San Diego - Coronado Bay Bridge Suicide Deterrent Project

State Route 75 & Interstate 5
11-SD-75 PM R20.1/R22.3 & 11-SD-5 PM R13.8/R14.3
Project Number 11-43063/1119000044
SCH No. 2020060290

Addendum to the 2022 Initial Study with Mitigated Negative Declaration

April 2026

Figure 2: Proposed Vertical Net Attachment System

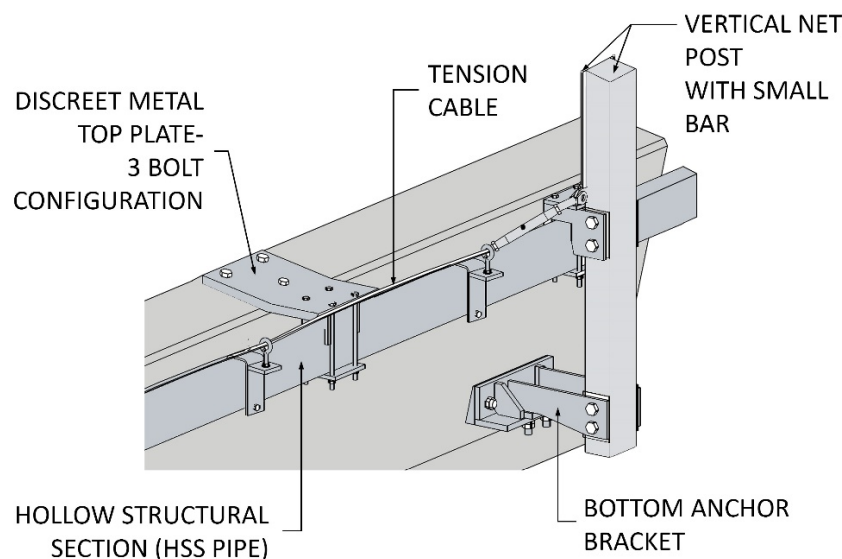
The 2022 MND proposed a metal continuous top plate that would be installed on top of the existing railing to provide connection brackets for the Vertical Net posts and anchorage for Caltrans Maintenance use. The new design for the Vertical Net post connections would install discrete metal top plates at the existing anchor bolt locations and a continuous hollow structural section (HSS) pipe behind the bridge railing. The posts for the Vertical Net would be attached to the pipe and the pipe would be attached to the railing via the discrete metal top plates.

This project change was proposed due to constructability and bridge capacity concerns. A metal continuous top plate would be difficult to fabricate due to the curve of the Bridge and inconsistent spacing of the existing anchor bolts. High accuracy would be needed to ensure the metal continuous top plate precisely matches the top of the bridge railing. Further, additional weight of the metal continuous top plate could affect the capacity of the Bridge and potentially result in additional bridge foundation rehabilitation work to occur in the water.

The 2022 MND's metal continuous top plate only required utilizing the existing anchor bolts and did not require additional drilling into the top of the bridge railing. This Addendum's discrete top plate does require new anchor bolts and would require additional drilling to install new anchor bolts into the top of the bridge railing. There are 3 configurations for securing the discrete metal top plate: 3-bolts, 5-bolts, and 7-bolts. The majority of the discrete metal top plates would utilize the 3-bolts configuration and would not require drilling additional anchor holes into the top of the bridge railing. The size of the 3-bolt configuration top plate would be approximately 13 inches by 19 inches (including the bevel edge) with a 1-inch thickness.

At locations with conflicts (such as minor bridge expansion joints and luminaires), the pipe must have a small gap and would utilize the 5-bolt configuration. The 5-bolt configuration would drill two new anchor bolts into the top of the bridge railing adjacent to the existing three anchor bolts. The 5-bolt configuration top plate is the same size as the 3-bolt top plate. The additional bolts are needed to ensure proper anchorage of the discrete metal top plate to the bridge railing and to maintain the structural stability of the pipe where there must be gaps.

The 7-bolt configuration would be used only at 8 locations for the large expansion bridge joints and end panels. The 7-bolt configuration would utilize the existing three anchor bolts and drill four new anchor bolts. The size of the 7-bolt configuration top plate would be approximately 25 inches by 19 inches with a 1-inch thickness. Design models demonstrated that the 5-bolt configuration is not sufficient at these locations, and a 7-bolt configuration is needed to ensure proper anchorage of the discrete metal top plate to the bridge railing.

Another change to the Vertical Net is the bottom anchor bracket. To provide stability and to prevent the posts from leaning, a counter anchor bracket will be drilled into the bridge railing at the bottom of each post. For most of the Bridge, the counter anchor brackets involve drilling two small $\frac{3}{4}$ inch rods into the outside face of the bridge railing. For locations that require additional stability such as the large expansion joints and deterrent end panels, the bottom anchor bracket would require drilling four small $\frac{3}{4}$ inch rods into the outside face of the bridge railing. The rods would be secured with high-strength adhesive and would not be visible to viewers on the bridge deck.

Figure 3: Rendering of Proposed Vertical Net

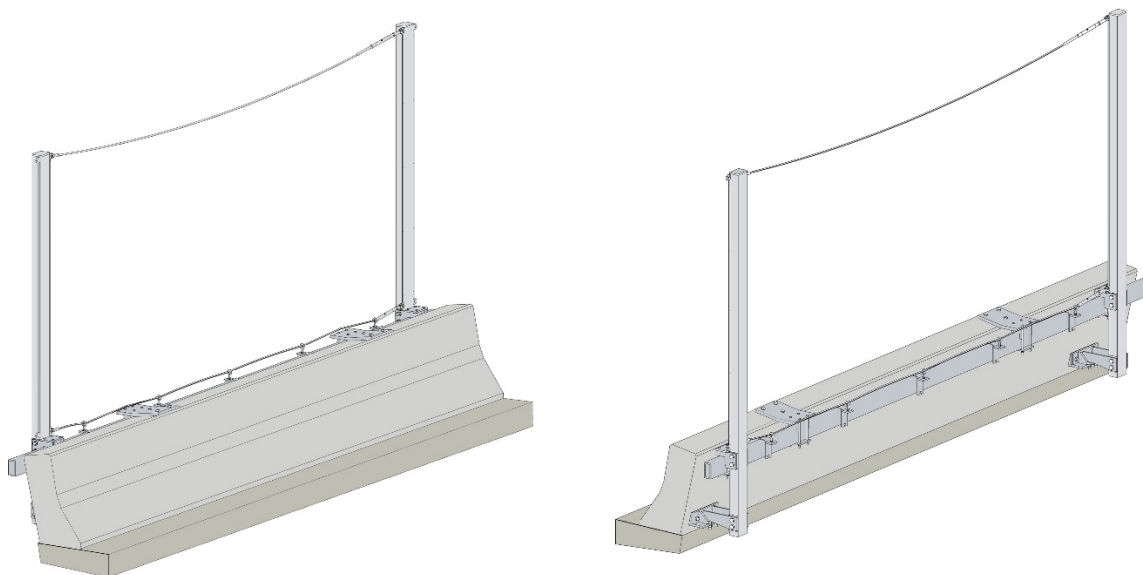
2022 MND Vertical Net Features and Parameters	2026 Vertical Net Design Refinement
The Vertical Net would be composed of an 8- to 10-foot-tall stainless-steel net affixed to top and bottom perimeter tension cables.	The Vertical Net would be 8 feet tall and attached to 8.5 feet tall posts. The 6-inch difference between the post height and the netting height is the sag of the netting between posts.

2022 MND Vertical Net Features and Parameters	2026 Vertical Net Design Refinement
The tension cables would be strung through and attached to fixed vertical posts approximately 20 or more feet apart.	The tension cables would be attached to the posts approximately 20 feet apart with a maximum deviation of 3 inches to avoid conflicts such as luminaires. Instead of being strung through, the tension cables would be isolated to each panel. During Preliminary Design, modeling showed that when cables were strung through multiple posts, the tension and sag of the netting couldn't be consistent. Caltrans Maintenance noted that continuous tension cables and netting could be challenging to replace and repair quickly and cost effectively if damaged. Additionally, with the use of isolated tension cables, the netting would have consistent tension and visual appearance throughout the Bridge.
The Vertical Net would be offset 4 to 8 inches behind the existing bridge rail.	The Vertical Net would be offset 8 inches behind the existing bridge rail.

Vertical posts would measure no more than 4 by 6 inches in thickness.	The vertical posts would be 4 by 6 inches with the longer side facing the roadway except at the large expansion bridge joints and end panels. The posts would have rounded edges. A small, vertical bar would be affixed to both sides of the posts. During preliminary design, modeling showed that connecting the netting directly to the vertical posts would result in uneven tension at the netting edges. Stringing the wire through a small, vertical bar resulted in consistent tension at the netting edge.

2022 MND Vertical Net Features and Parameters	2026 Vertical Net Design Refinement
Posts would be similar in visual quality to brush stainless-steel or brushed aluminum, with ground smooth welds the same color and reflective quality of adjacent material.	The posts would be stainless-steel with grounded smooth welds the same color and reflective quality of adjacent material.
The Vertical Net would be composed of an unpainted stainless-steel netting, with a maximum 2-millimeter (mm) wire size.	The Vertical Net would be composed of an unpainted stainless-steel netting with a 1.5 millimeter wire size.
The net may have a slight angle up to 15 degrees to follow the splay of the existing concrete rail.	The net will be near vertical (i.e. approximately 0 degrees).
The design would use top tension cables no larger than 19 mm that would hold the woven mesh netting between posts.	The tension cables would be 12 mm. The tension cables would frame the netting on all four sides instead of just the top and bottom. At the top of the netting, the tension cables will be topped with wire spikes spaced every 4 inches.

Figure 7: Proposed Camera Locations

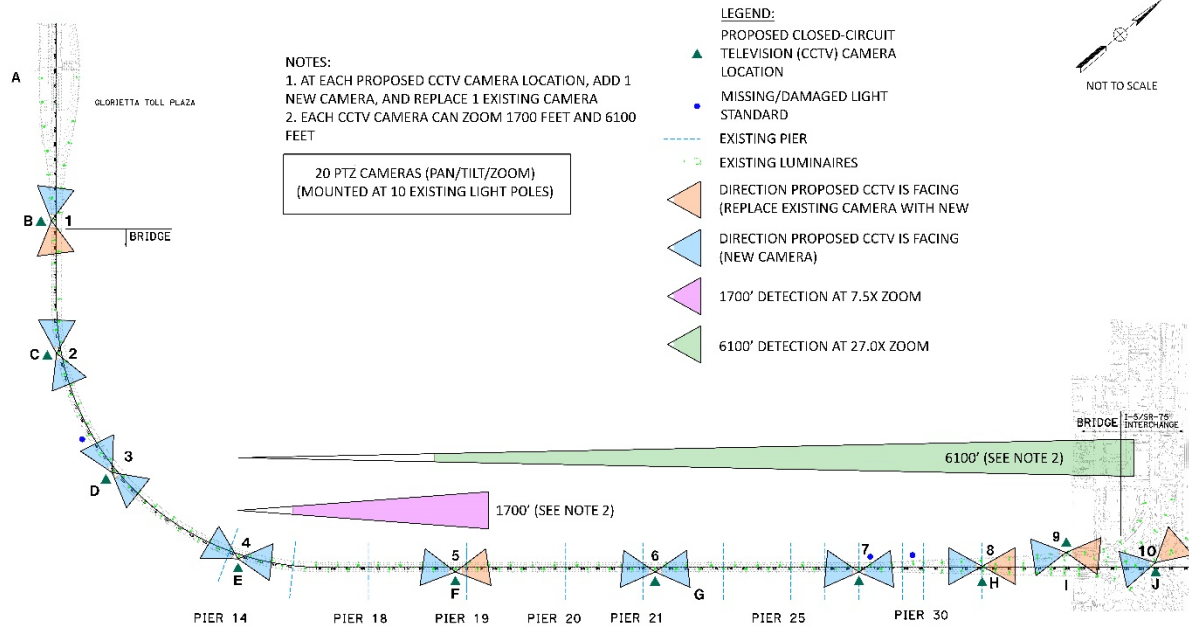
The 2022 IS/MND proposed a total of 10 cameras(5 new, 5 upgrades to existing) on 10 luminaries. This project change proposes to install a total of 20 CCTV cameras at 10 locations. Each location would have 2 CCTV cameras to provide analytical and complete visual coverage of the Bridge. At 5 locations, the existing single-camera systems would be removed and replaced with new dual-camera systems. At the remaining 5 locations, new dual-camera systems would be added to existing luminaries. Luminaires with aircraft lighting would not be impacted by the proposed dual-camera systems.

Figure 8: Rendering of Dual-Camera System

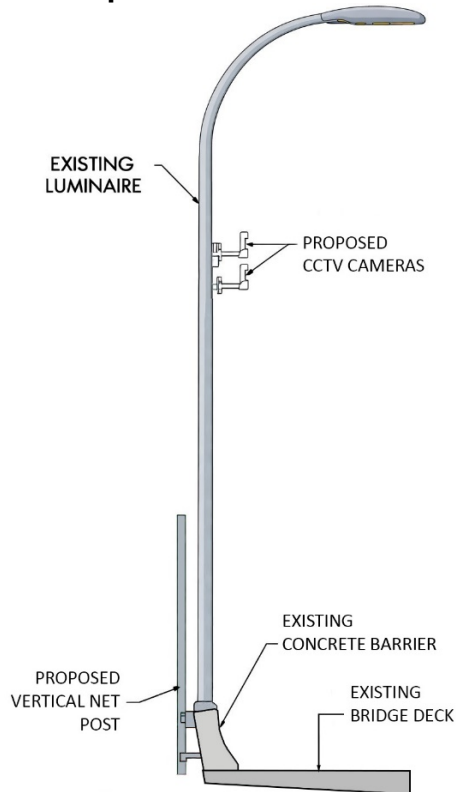
The proposed dual-camera system would be approximately 21 feet above the bridge deck with 2 feet of space between the lower and upper cameras facing opposite directions. The new cameras would be compact and similar in size to the existing cameras. The cameras would be mounted onto existing luminaires using U-bolts and plates. Wiring for the new cameras would be routed inside the luminaire and would not be visible to drivers. All existing cameras and camera wiring conduits would be removed.

Figure 11: Proposed Bridge Substructure Bay Walkways

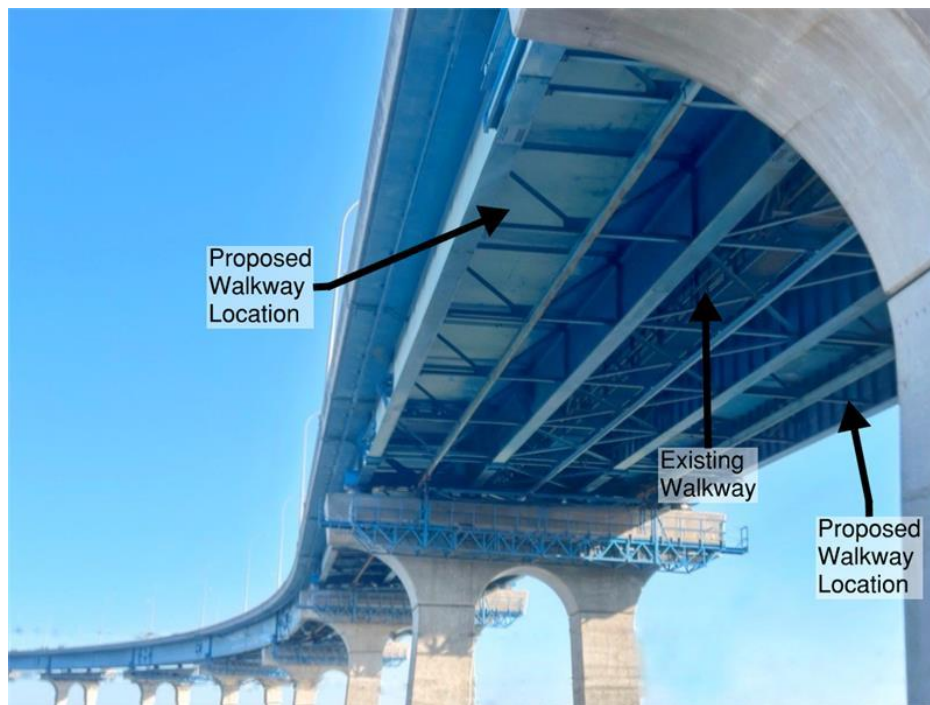
Due to the height of the Vertical Net, the Under Bridge Inspection Truck (UBIT) that's currently used for inspections and maintenance would no longer be able to reach certain areas under the Bridge deck. The 2022 MND proposed enclosing the Bridge's substructure bays with grated flooring to retain access to the areas under the Bridge deck without the use of the UBIT. Instead of full enclosures, this project change proposes to construct direct access maintenance and inspection walkways (also known as catwalks) under the Bridge in the substructure bays.

The walkways would be installed at the approximate mid-heights of the existing bridge girders. Access ladders with a protective steel cage would also be installed to provide access to the upper and lower inspection walkways within each bay.

This project change was developed due to concerns about weight of materials added to the Bridge and impacts to the schedule. Compared to full bay enclosures, the walkways require significantly less material, are easier to assemble, faster to construct, and less visible to the public.
